TASKI swingo 2500 / 3500 Subassembly: Tank

## Freshwater-tank 4121877 (19600-43)

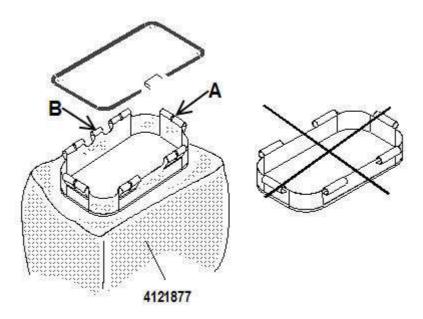
Based on field information, the freshwatertank has been analysed by the Technical Center and they have taken measures to increase its life expectancy.

- The fixation loops on the bag are wider and larger in diameter
- The single loops are divided into two parts (A) and therefore easier to assemble
- The loops are longer and therefore the strain is reduced
- An additional loop (B) reduces the risk for of mounting the freshwater tank the wrong way round
- The bag material is now PUR soltane blue
- The characteristics and durability are the same as the old bag (Polyether PUR)
- The water volume remains at 95 liter
